SERVICE BULLETIN

Service Bulletin No. 671B
(Supersedes Service Bulletin No. 671A)
Engineering Aspects are FAA Approved

SUBJECT: Fuel Pump Leak Inspection and Diaphragm Replacement, Hartzell Engine Tech (HET) Alert Service Bulletin No.233

Alert Service Bulletin No. 233

Figure 1 - 200F & 202F Identification

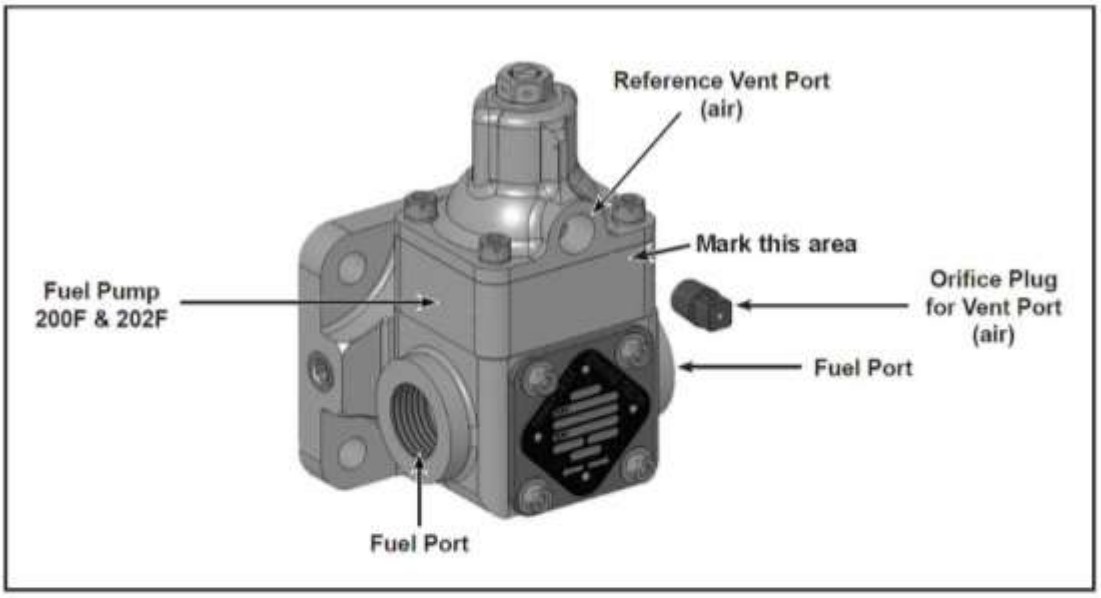
(a) Inspection of the orifice plug requires only a visual inspection. Look around the plug and into the orifice for fuel or blue dye stains. Refer to Fig. 1, Fig. 2, or Fig. 3.

(h) Mark field repaired pumps with a green dot on the valve housing front face (200F, 202F, and 500F) or top of valve housing cover (201F) using an indelible paint marker. Dot size to be 1/8 inch to 1/4 in diameter and must not overlap or obscure any existing markings. See Figures 1 through 3.

Figure 4 - Typical HET Series Fuel Pumps

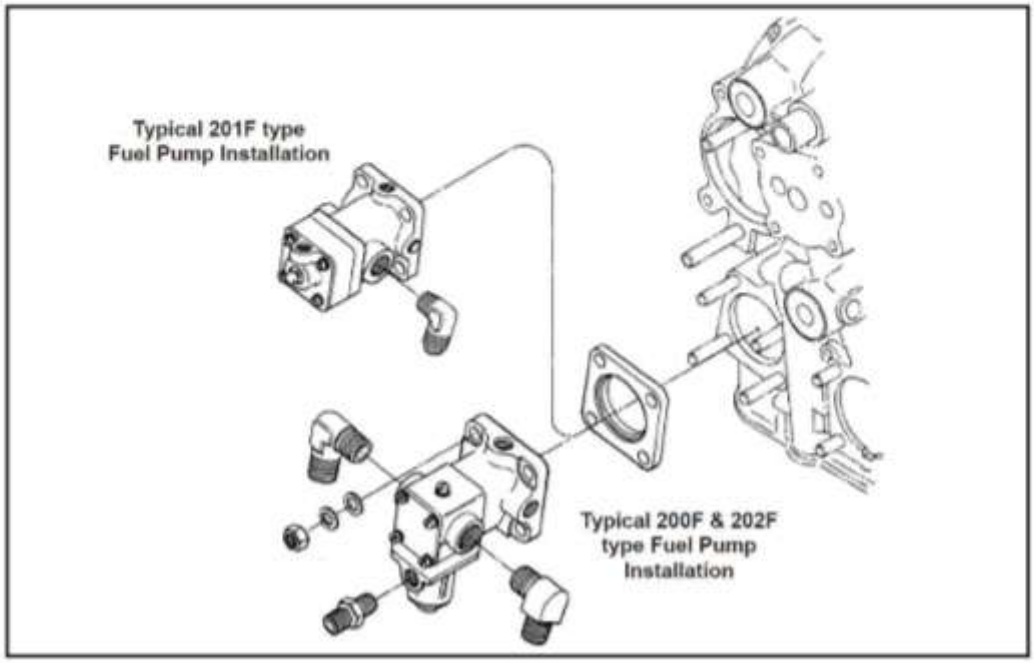
(c) If removed, reinstall the fuel pump cooling shroud and air hose (if applicable) in accordance with the latest engine/airframe service instructions or maintenance manual and continue to 3.D.(1), Return to Service. Refer to Fig. 4.

Figure 6 - Typical HET 201F Fuel Pump Plumbed to Upper Deck Reference

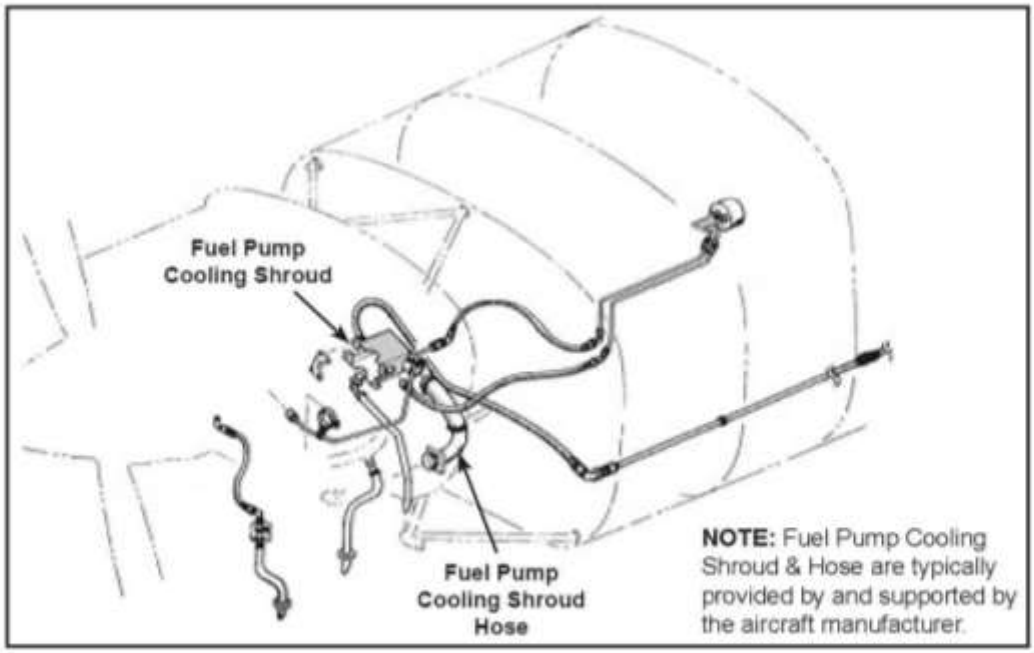
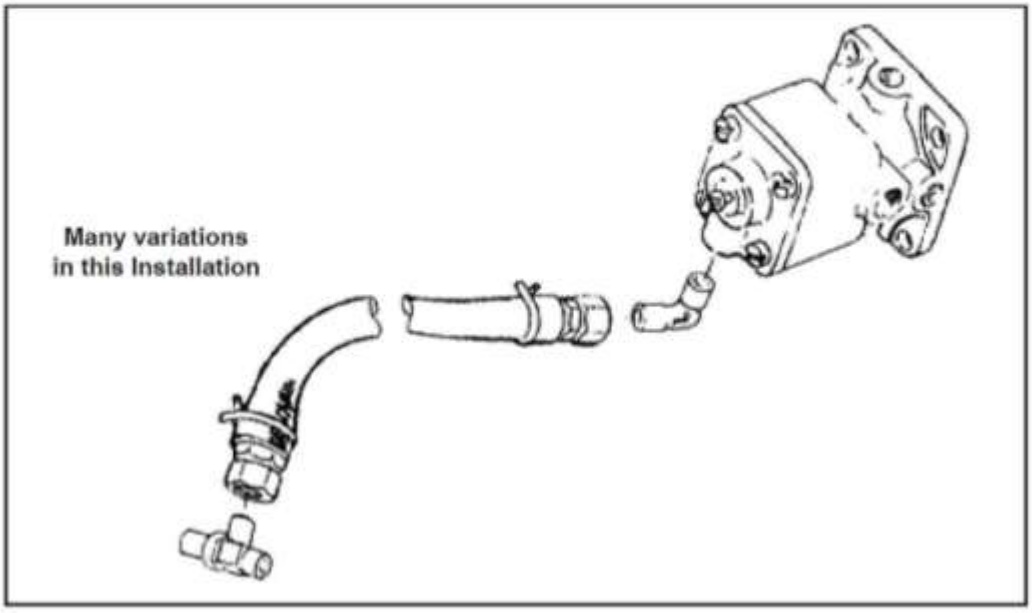
(b) Inspection of the upper deck reference line requires that the line be disconnected and the inside of the fitting be inspected for fuel or blue dye stains. Refer to Fig. 5 and 6.
